Meeting Date: October 14, 2025 Item Number: 25-09	From: Mike Malyy, Caltrans
Sponsored By: Amjad Obeid, Caltrans	Presented By: Mike Malyy, Caltrans
Description: Request for review and recommendation to finalize CA MUTCD 2026 Part 3 titled "Markings" proposed documents that have been revised in response to 10/2/25 CTCDC Meeting comments and is being prepared to adopt Federal Highway Administration's National MUTCD 2023 (11th Edition) before the January 18, 2026, deadline.

California Traffic Control Devices Committee Agenda Item Report

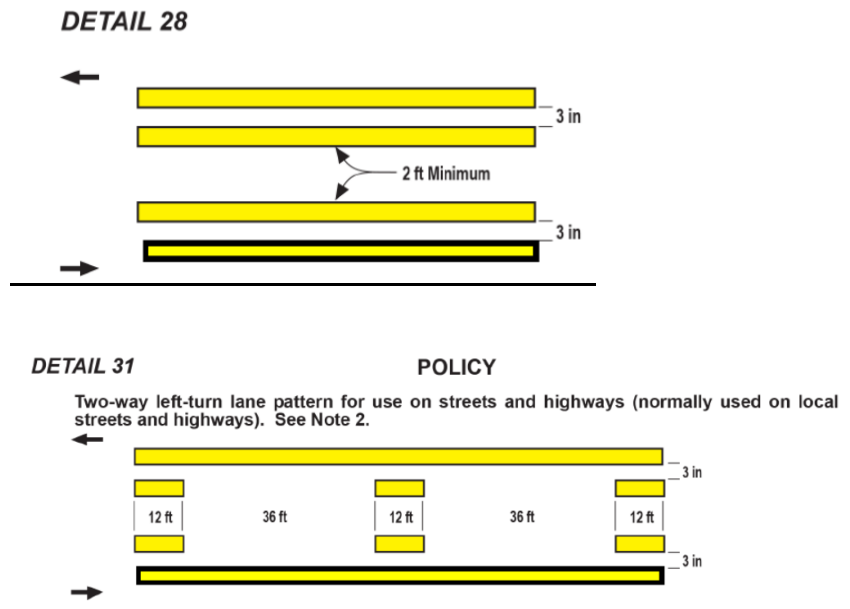
CTCDC comment: Was there a 4-inch black stripe between two yellow stripes? But it says 3-inch. Also referred to Figure “3A-107(CA)” for the dimensioning issue.

Caltrans response: The National MUTCD does not mandate the exact spacing between double lines (see Section 3A.04, paragraph 03). On the other hand, speaking Johnny Bhullar's words: "California pavement marking details have been around for many years in our manuals, they have served a purpose and have been used as a reference by practitioners to install pavement markings on roadways when designing projects or maintaining existing markings and we are not aware of them posing any safety concerns, rather they have helped improve safety of the road users." ... "In our current effort, Steve Pyburn hasn't raised this as an issue either."

Figure 3A-108 (CA). Two-Way Left-Turn Lanes

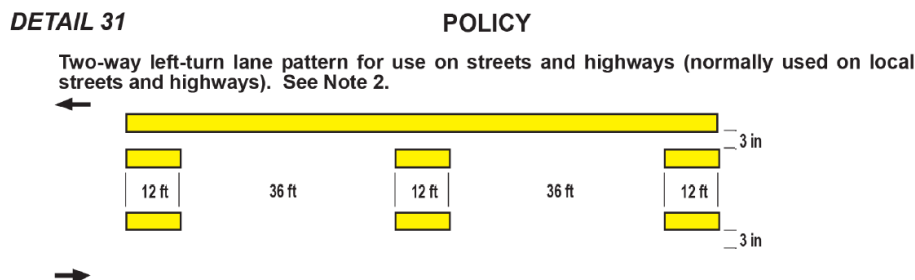
CTCDC comment: The bottom edge line appears thicker than the top edge line, as well as the dashed lines on Details 28 and 31.

Caltrans response: The visual inconsistency, such as the notably thicker bottom edge line, is due to this image being draft preparation material.

These two edge lines were omitted from the previous CA MUTCD publication (see the picture below). They were added to this existing document using Adobe Acrobat, a digital editing tool, as part of our initial revision for the forthcoming publication.

In the final product, all graphic details will be presented in a consistent style and scale, ensuring all similar lines have the appropriate, uniform thickness.

Figure 3B-23. Examples of Parking Space Markings

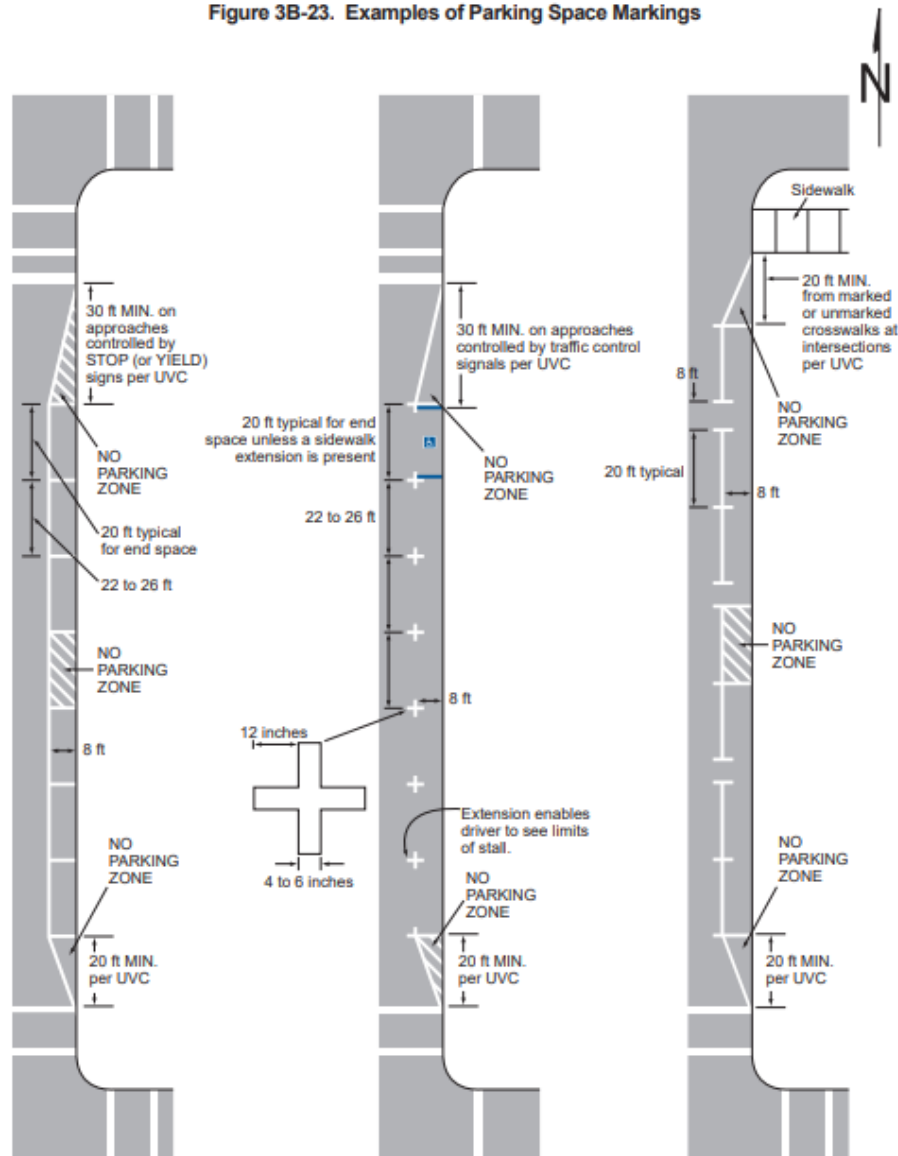
CTCDC comment: This Figure still refers to the Uniform Vehicle Code (UVC) and doesn't correspond with the CA "Daylighting" safety measure.

Caltrans response: The 30-foot minimum for parking restrictions at controlled intersections is set as the default design standard. While CA law (CVC 22500, per AB 413) sets the legal minimum at 20 ft from a crosswalk, the 30-foot standard provides a necessary higher margin of safety and superior sight distance.

However, in situations where Right-of-Way constraints are severe or where a thorough Engineering Study conclusively demonstrates that the legal is sufficient to meet sight distance requirements and accessible route connectivity without compromising safety, then Engineering Judgment may be applied to use the reduced distance.

20. CTCDC Comment – [Figure 3B-104\(CA\)](#):

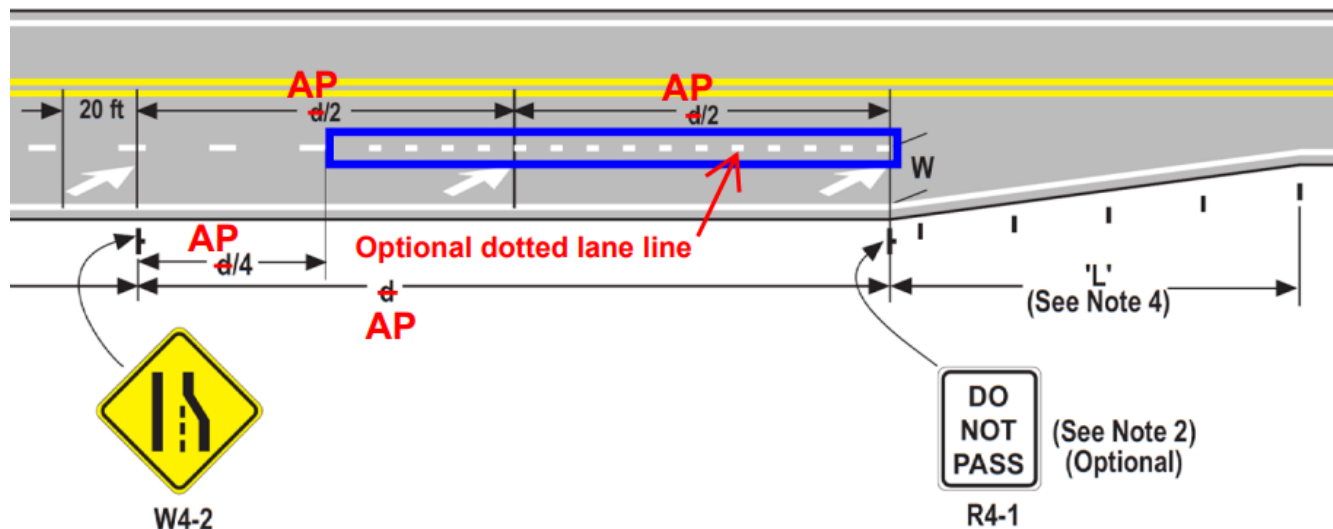
CTCDC comment: The optional dotted line, and the reason that was shown there, instead of just going with the federal standard.

Caltrans response: The optional line is included in corresponding Federal Figure 3B-14.
